Safety Analysis Report
for the
West Valley Melter Package

SARWVMP-01

Responses to the U.S. Nuclear Regulatory Commission Requests for Additional Information on the Safety Analysis Report for the West Valley Melter Package (SARWVMP-01)

USNRC Docket Number 71-9797

Figure 2-5. Configurations for Tie-Down Assessment

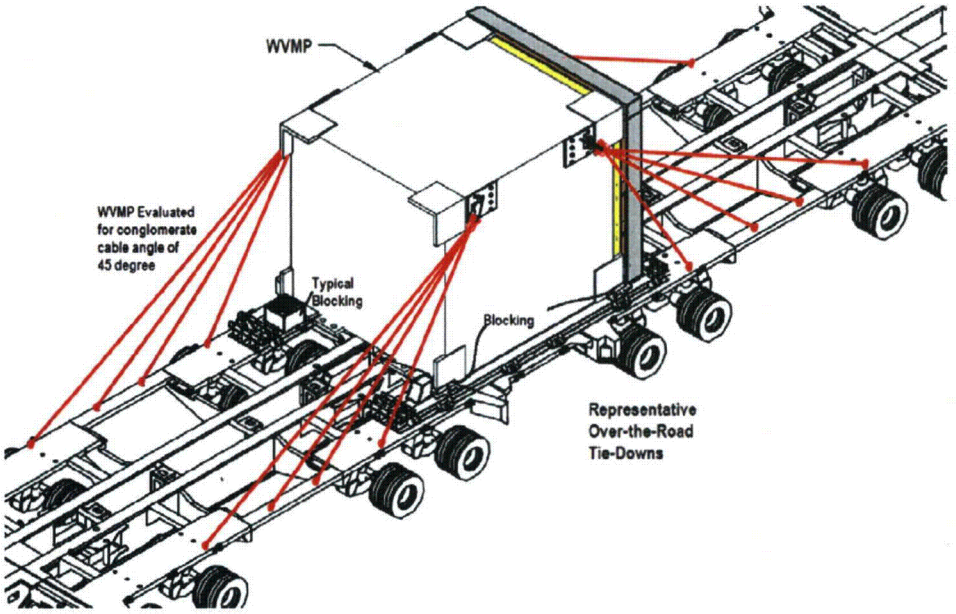
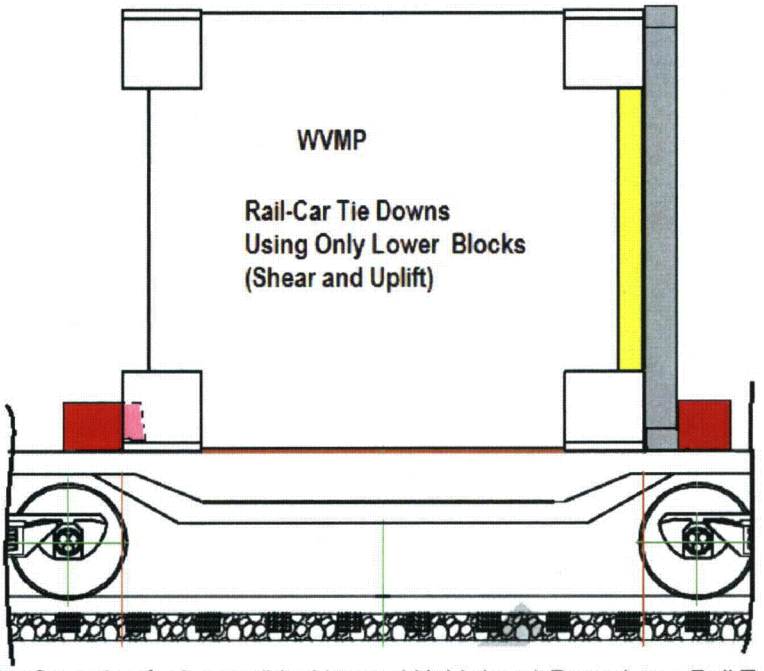
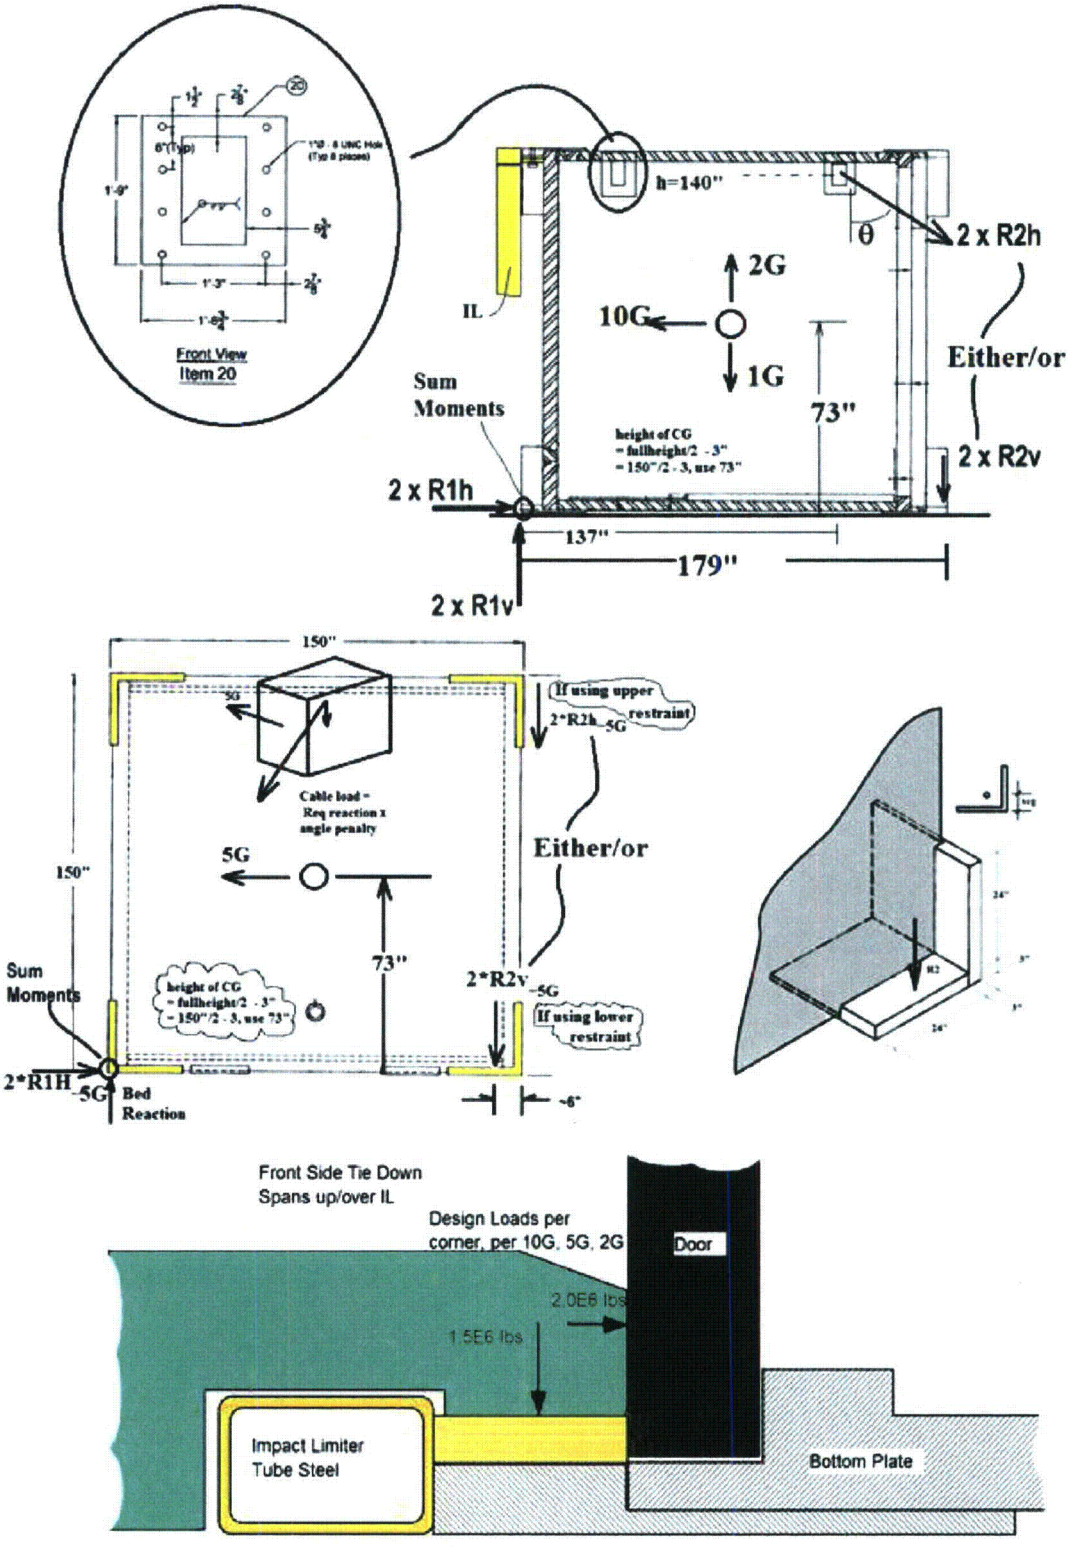
RAI: Provide a detailed description and analysis for the tie-down configuration that will be used to secure the package to a trailer and/or rail car, including the corresponding free body diagrams that indicate all points of force application and all points of restraint.

DOE response: The WVMP will be tied down for two modes of transportation, one configuration for heavy haul truck and another for rail transport. Information has been added to Section 2.5.2 to clarify this point.

Changes to the SAR: The tie down section was revised to show tie-down methods used in road transport and in rail transport. A new figure was added to depict both arrangements. The old figure 2-5 (now 2-6) was revised to show shear and compression restraint terms to match the calculations.

Figure 3-10. Variation of Average LDCC and WVMP Air Pocket Temperatures during the HAC Fire Scenario, With Natural Convection in the WVMP Air Pocket

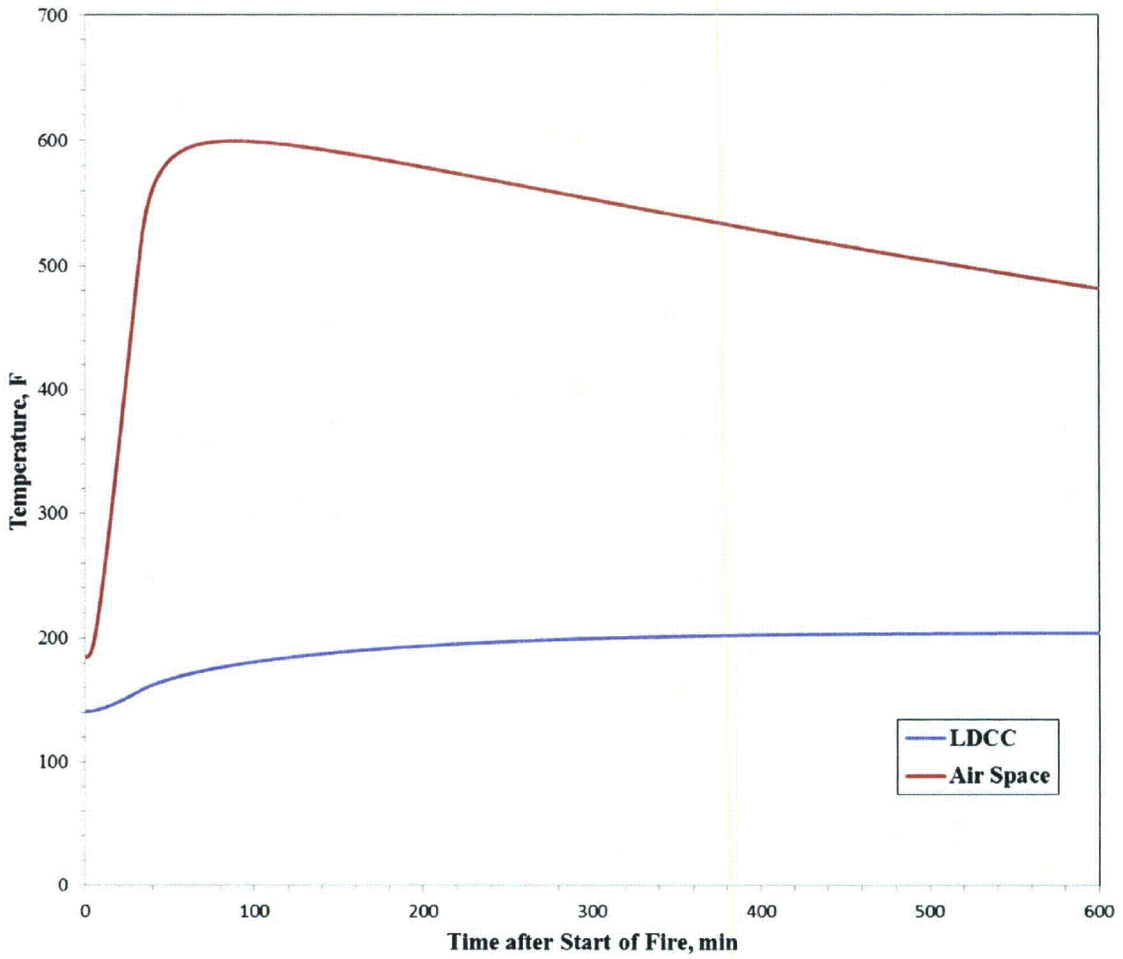
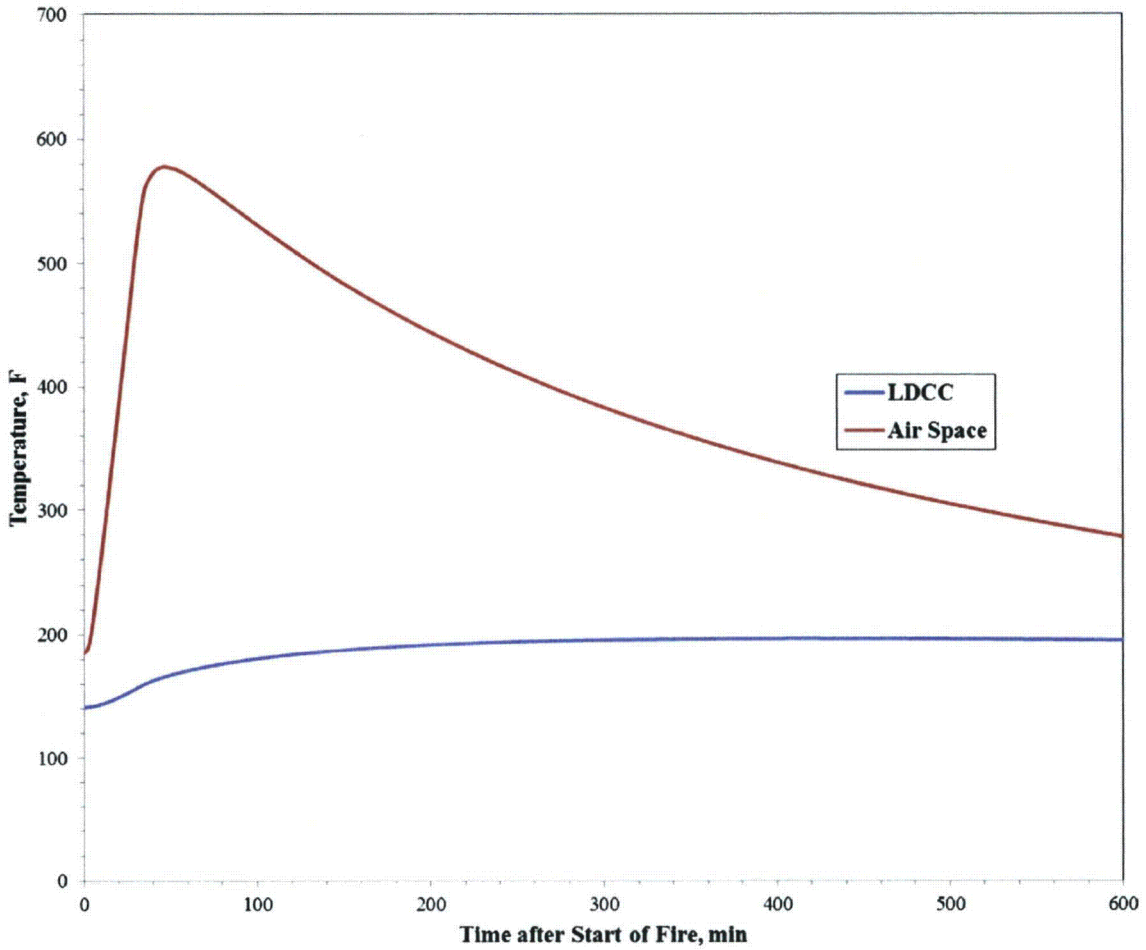
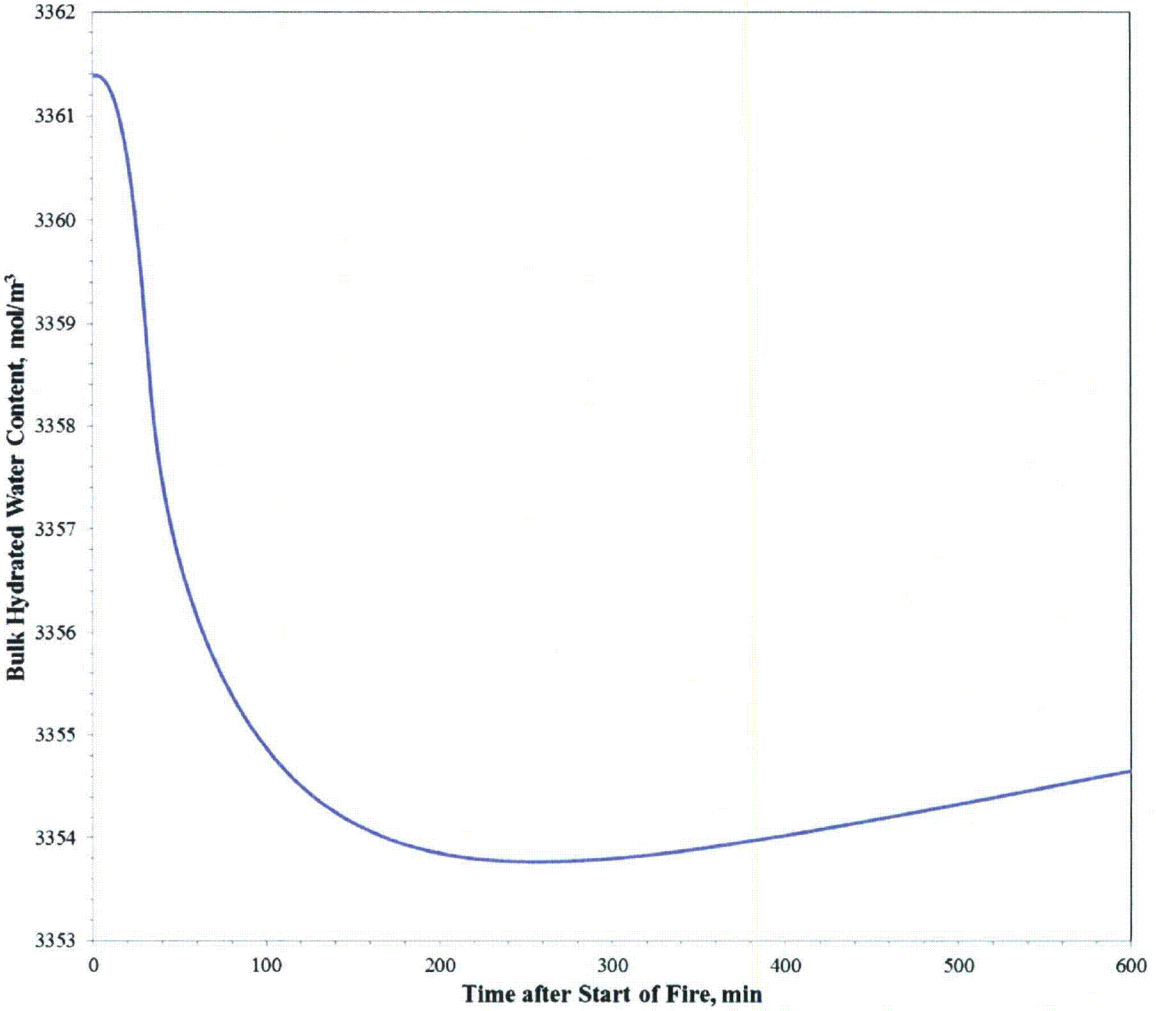
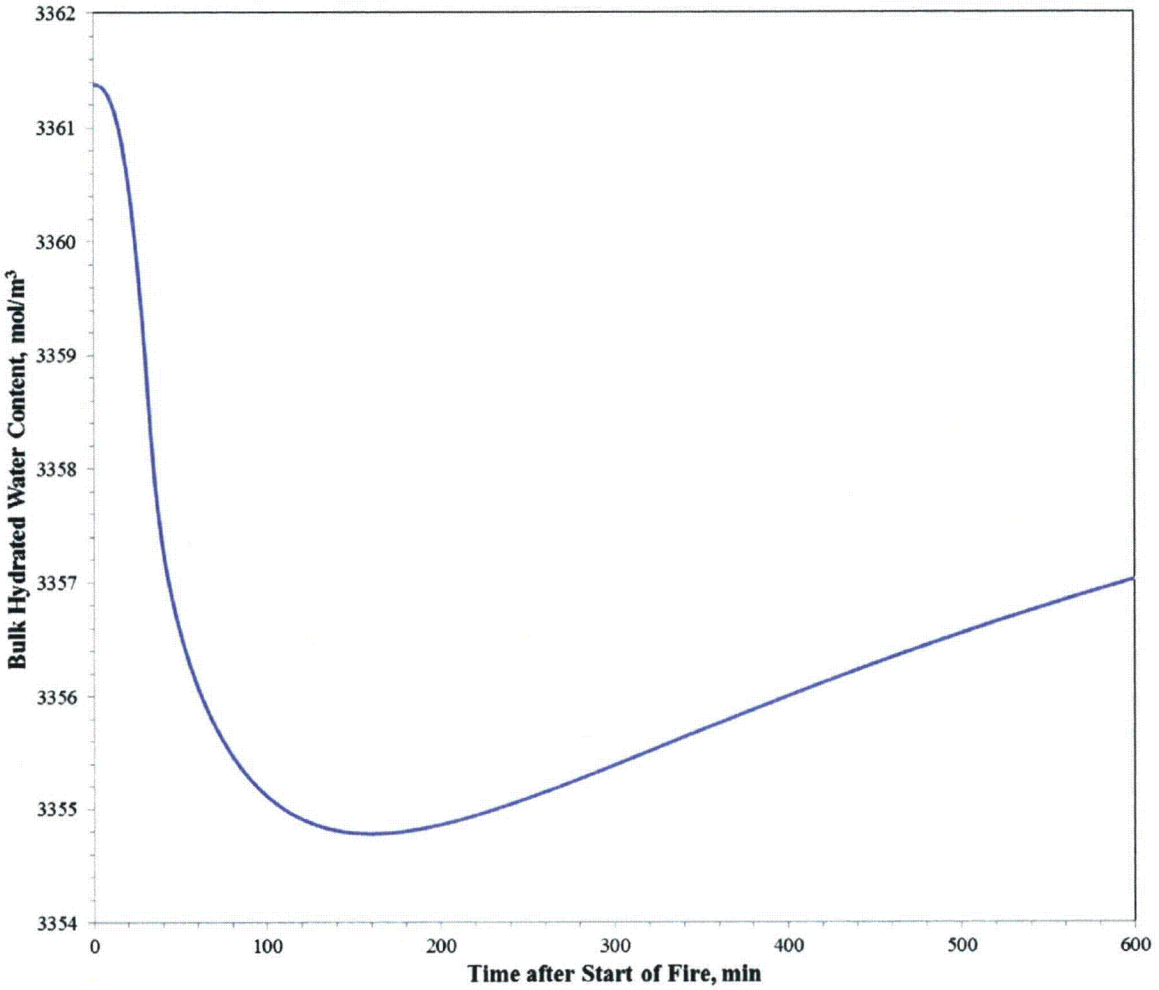
RAI: Provide calculation results (tables, figures, etc.) to demonstrate that, during an HAC fire, the omission of natural convection heat transfer in the package air pocket is conservative.

However, the applicant did not provide results for the case when natural convection is included. The applicant needs to provide results for both cases in tabulated and graphic form for the staff to determine the adequacy of the analysis assumptions.

DOE response: The additional results, including natural convection, were reported in the revised calculation note supporting Rev 0A of the SAR in Appendix 3.5.4 but were omitted from Chapter 3 since they were not the bounding pressure. The results from the calculation in Appendix 3.5.4 have been incorporated into the text of Chapter 3.
